# North Oakville Creeks Subwatershed Study Addendum

September 5, 2007

**Addendum  
to  
North Oakville Creeks  
Subwatershed Study**

This addendum summarizes changes required to the North Oakville Creeks Subwatershed Study (NOCSS) to reflect the outcome of the mediation and settlements for the North Oakville Secondary Plan.

**Figure 7.2.1  
Implementation Process**

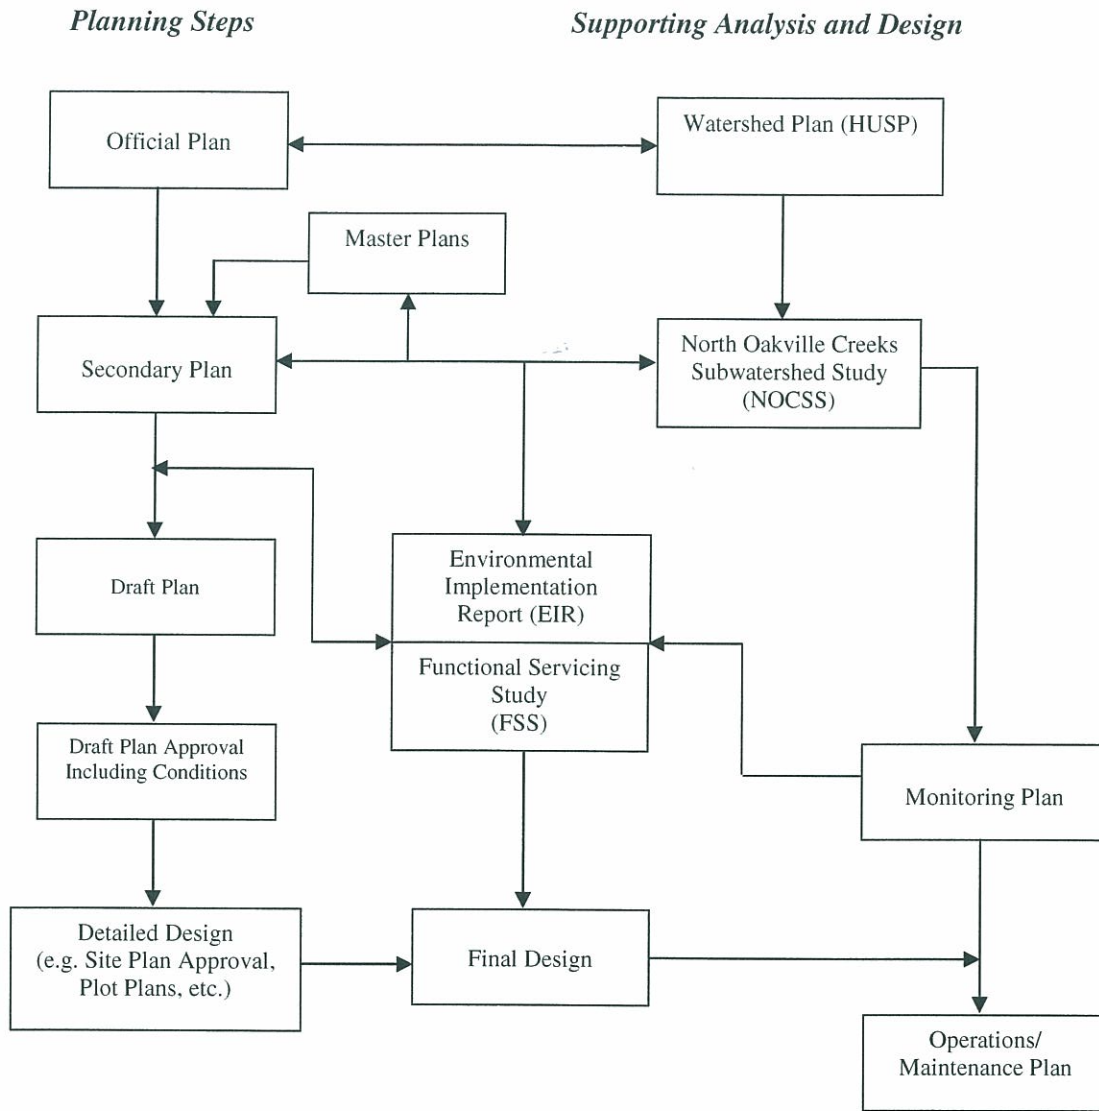
- Replace Figure 7.2.1 with attached new Figure 7.2.1
